**CITY OF CORCORAN**  
**Corcoran Planning Commission Agenda**  
**December 1, 2022 - 7:00 pm**

<b>Planning Commission Meeting:</b> December 1, 2022	<b>Prepared By:</b> Nicholas Ouellette through Kendra Lindahl, AICP
<b>Topic:</b> PUBLIC HEARING. Rezoning, Preliminary Planned Unit Development (PUD) Plan and Preliminary Plat for “Pioneer Trail Industrial Park” (PIDs 32-119-23-34-0013, 32-119-23-34-0007, 32-119-23-43-0005 and 32-119-23-43-0006) (City file no. 22-039)	<b>Action Required:</b> Approval

# PIONEER TRAIL INDUSTRIAL PARK

Figure D: Pioneer Trail Landscape Plan

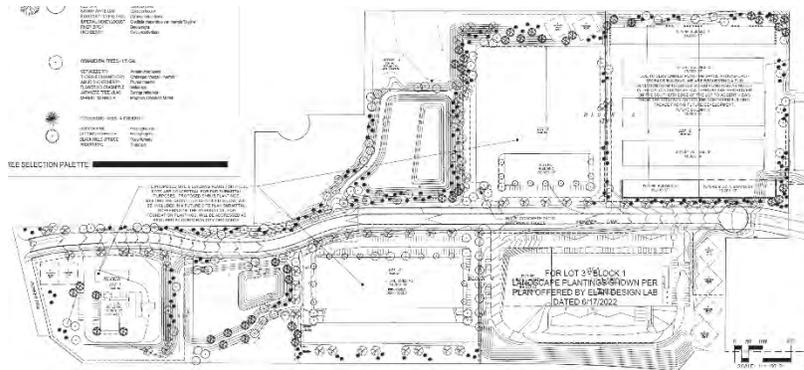
The 117 trees that are not provided on Lot 2, Block 2 are provided on Lot 1, Block 2. However, it appears additional trees could be planted along the north and east property lines of Lot 2, Block 2 to better screen the self-storage facility from adjacent residential properties. This area could also be used to provide the required shrubs. Staff has included a condition requiring additional landscaping in the northwest portion of the lot, but supports the idea of shifting the other trees to the east near the Wagon Wheel neighborhood. The Planning Commission may wish to discuss.

Figure E: Pella Corporation Landscape Plan

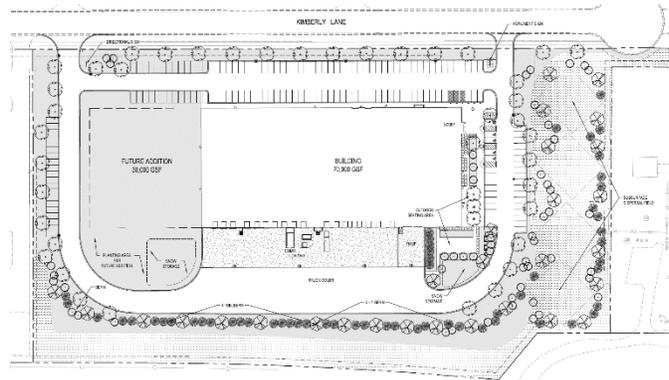
The applicant has provided 137 trees in addition to the required 70 overstory trees for the Pella Corporation site (Lot 3, Block 1). The additional overstory trees should be considered a PUD benefit. Plans also show tree preservation which is considered a PUD benefit; however, some areas of tree preservation appear to conflict with the small utility corridor north of Kimberly Lane. The applicant shall update tree preservation plans to show where trees will actually be preserved through construction. If trees marked for preservation on plans are removed during construction, the applicant shall be required to provide an equivalent caliper inch replacement for the lost trees.

**C9.1**  
 Preliminary Site Plan  
 Pella Building

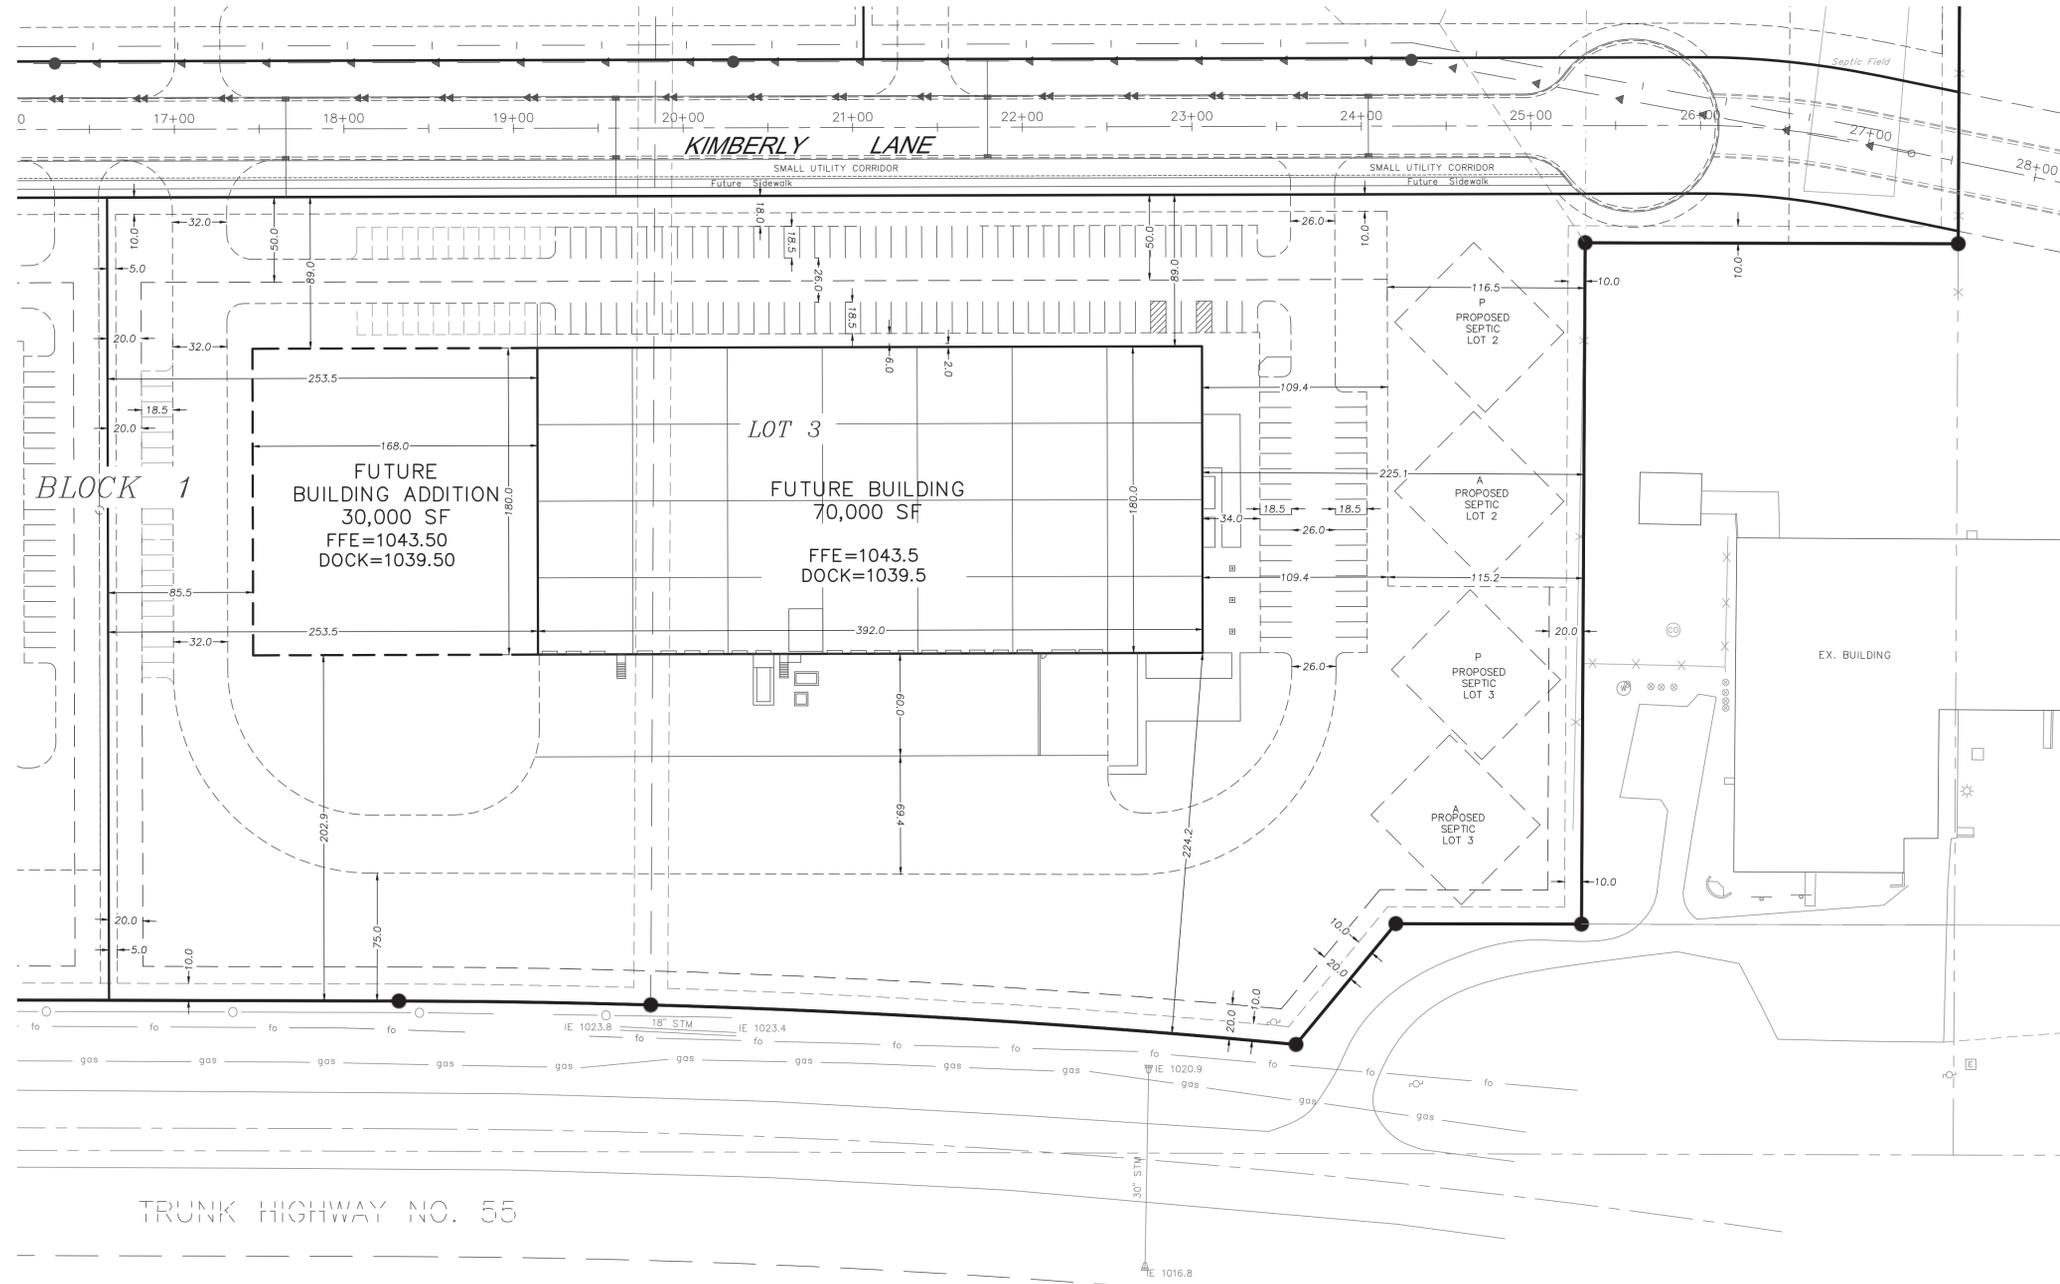
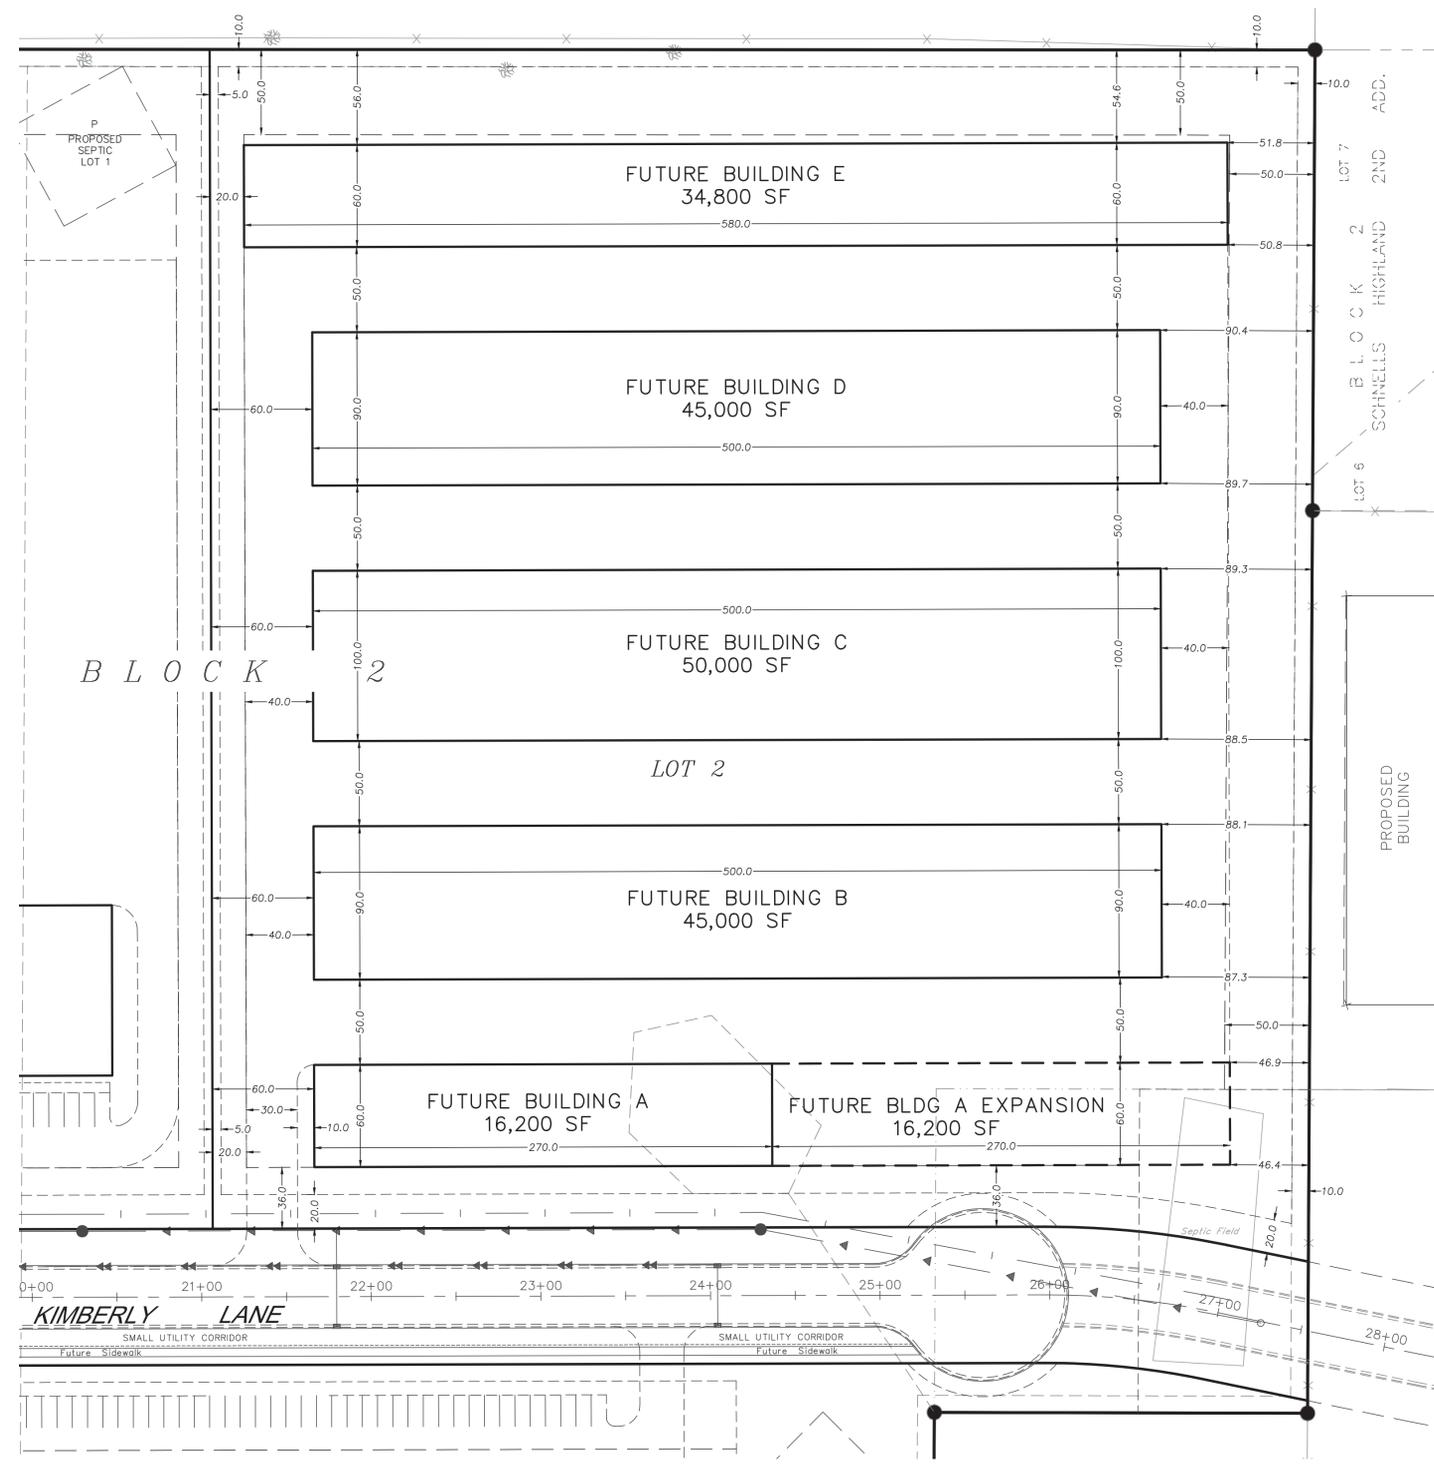
The Pella Corporation plans show ground mounted mechanical generator and transformer in the loading area south of the building. Staff has included a condition requiring the applicant to provide plans for screening for the mechanical equipment to ensure compliance.

Plans for the Pella Corporation show a compactor in the loading area south of the building. Section 1060.02 of the Zoning Ordinance permits exterior storage of trash if it is stored within an accessory building or in closed containers within a totally screened area. The trash enclosure materials should be compatible with the design of the building. Staff has included a condition that enclosure details be provided to the City for review and approval to ensure that trash is adequately screened in the front yard.
